## Product Change Notification

### MultiTech Conduit<sup>®</sup> Programmable Gateway

Date: January 27, 2022

PCN 01272022-001 (Conduit - mPower)

2. **Hardware Version:**

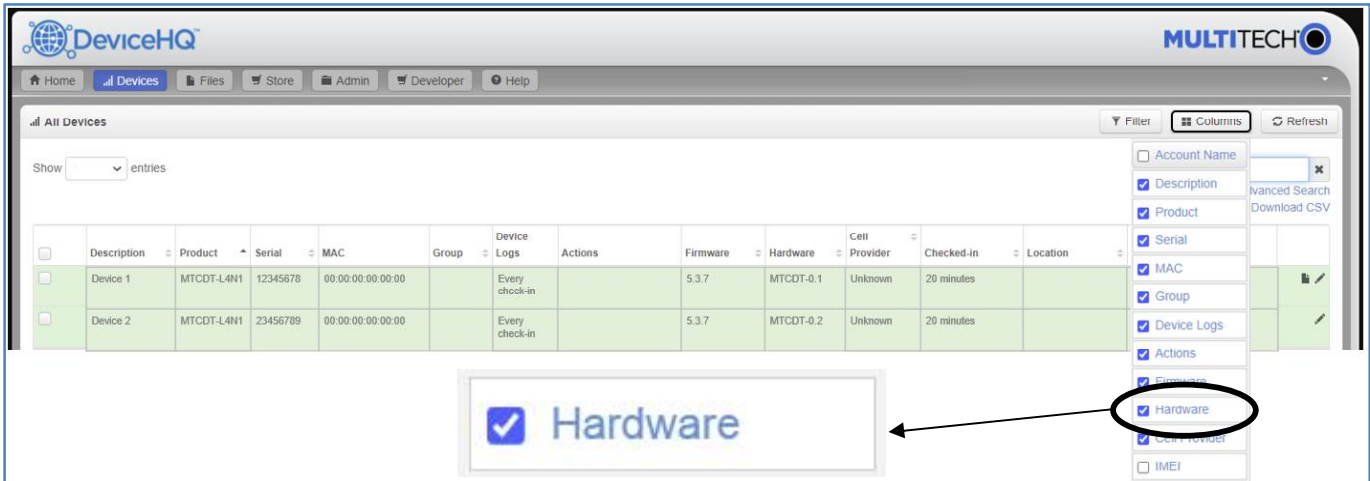
- MTCDD device with original components – Hardware Version “MTCDD-0.1”
- MTCDD with substitute components – Hardware Version “MTCDD-0.2”

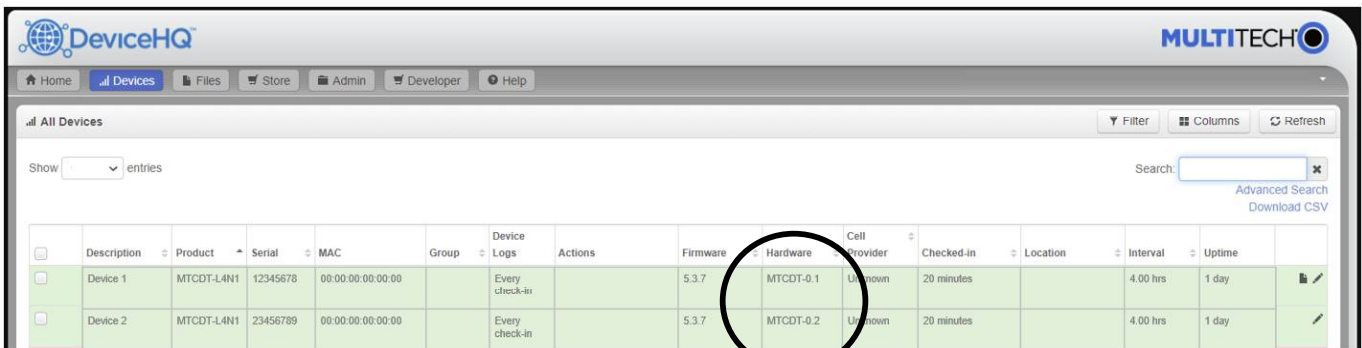
- **MTCDT-0.1** - MTCDT device with original components
- **MTCDT-0.2** - MTCDT with substitute components

### Changes to Debug Connector and Cable

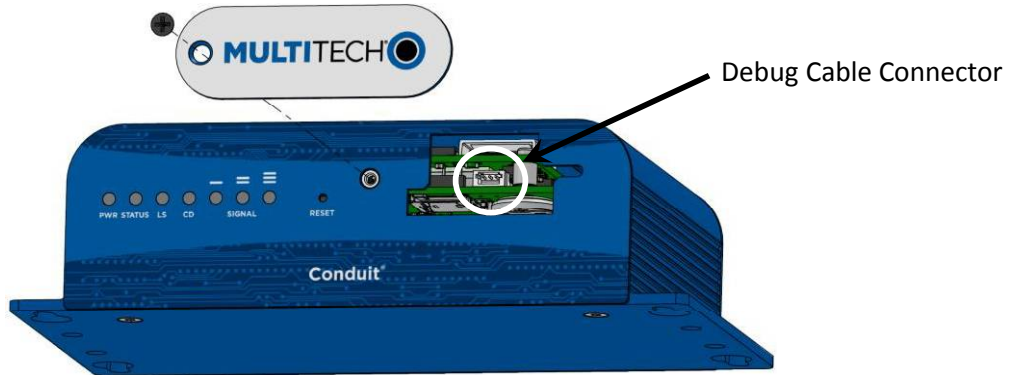
The current debug cable connector is a standard USB Micro B Connector. This connector has been available on Conduit devices for several years. A standard USB A-Male to Micro B cable is used to connect a host device to the Conduit.

Conduit devices with substitute components will ship with a custom 3-pin cable connector:

- A new 3-pin connector is used in place of the USB Micro B connector
- A custom USB A-Male to 3-pin connector cable is needed to connect a host device to the Conduit
